## Agenda Item # 7

### SUB-003173 -2024

Gawrychowski Subdivision

- Subdivision approval to create four (4) legal lots of record from one (1) existing metes-and-bounds parcel.

## DETAIL SITE PLAN

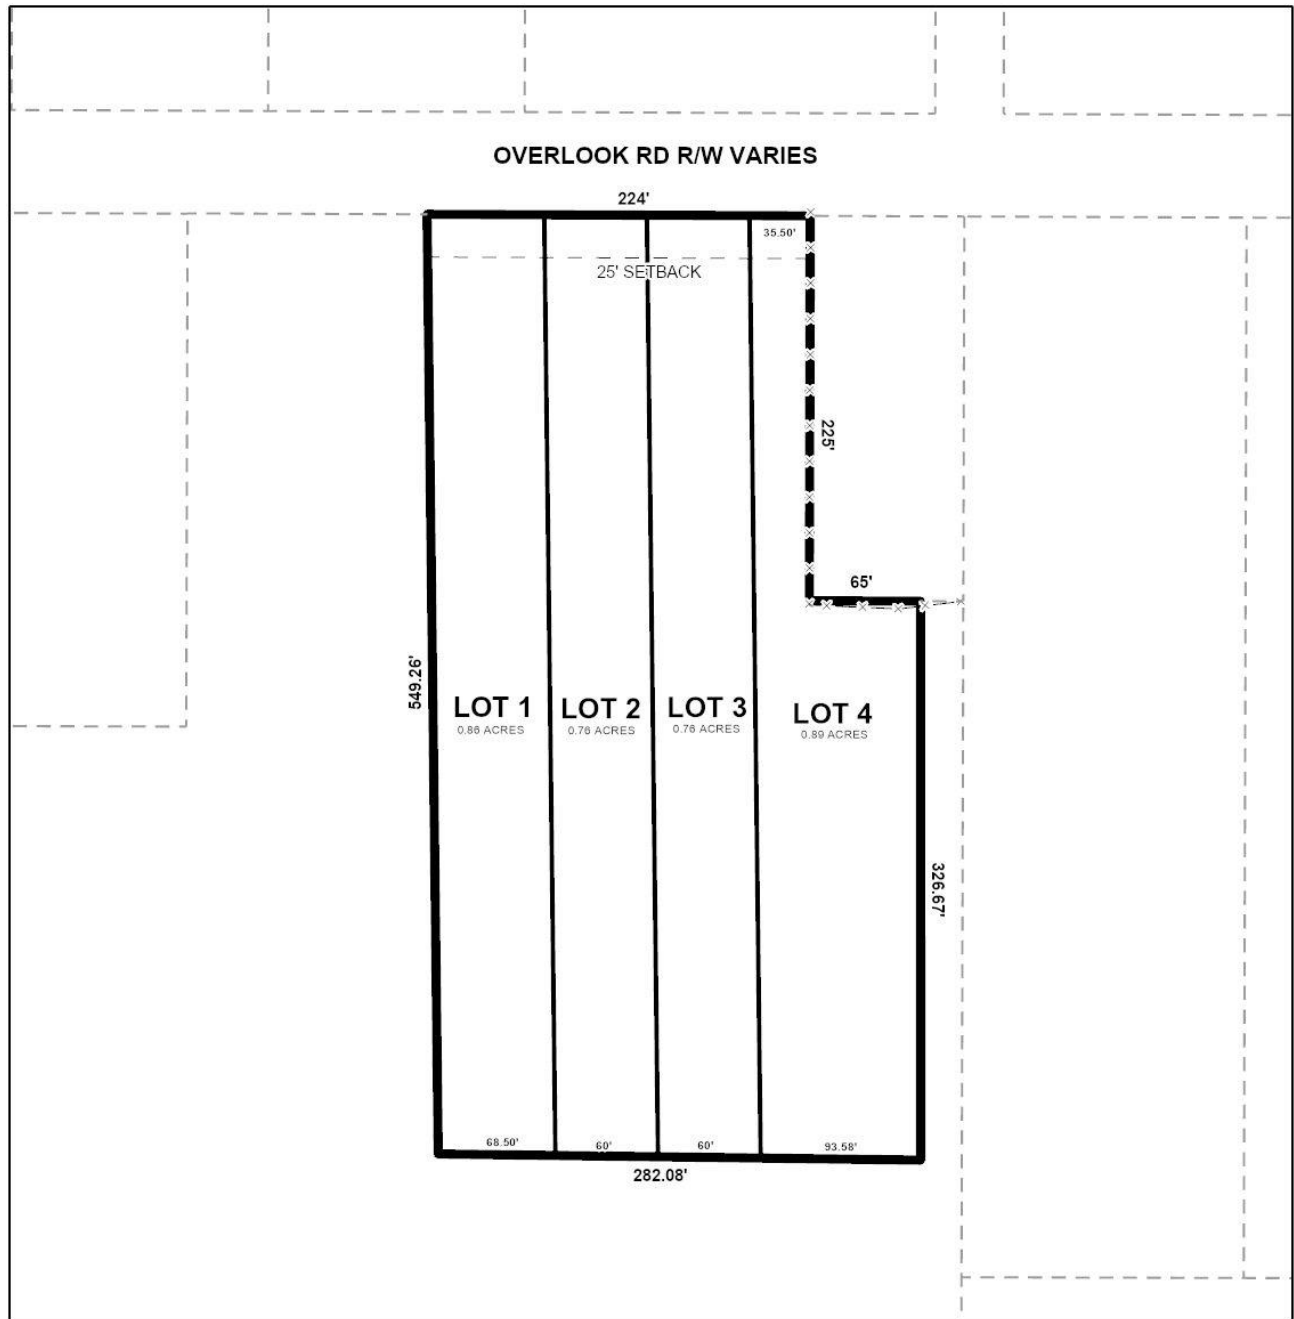
The preliminary plat indicates a 25-foot minimum building setback line along the entire street frontage for all proposed lots. However, as only Lots 1, 2 and 3 are at least 60 feet wide along the street frontage, the 25-foot minimum building setback line should be retained as illustrated on these lots only. The 25-foot minimum building setback line should be revised on Lot 4 to be measured from where the lot is at least 60 feet wide. The lot size labels in both square feet and acres should be retained on the Final Plat, if approved, or a table should be furnished on the Final Plat providing the same information.

As all proposed lots would exceed the depth-to width ratio of Section 6.C.3. of the Subdivision Regulations, a waiver of that section would be required, if approved. Lot 4 would be a "flag lot" which is generally not allowed by Section 6.C.9. of the Subdivision Regulations. However, exceptions are allowed due to pre-existing man-made barriers which may cause an undue hardship on the land owner. As the adjacent property to the East limits the street frontage for Lot 4, a waiver of Section 6.C.9. would seem justified.

1. Retention of the right-of-way width of Overlook Road on the Final Plat;

2. Retention of the 25-foot minimum building setback line for Lots 1, 2 and 3 as illustrated on the preliminary plat;
3. Revision of the plat to illustrate the 25-foot minimum building setback line for Lot 4 as measured from where the lot is at least 60 feet wide;
4. Retention of the lot size labels in both square feet and acres on the Final Plat, or the furnishing of a table on the Final Plat providing the same information;
5. Compliance with all Engineering comments noted in this staff report;
6. Placement of a note on the Final Plat stating all Traffic Engineering comments noted in this staff report;
7. Compliance with all Urban Forestry comments noted in this staff report; and,
8. Compliance with all Fire Department comments noted in this staff report.
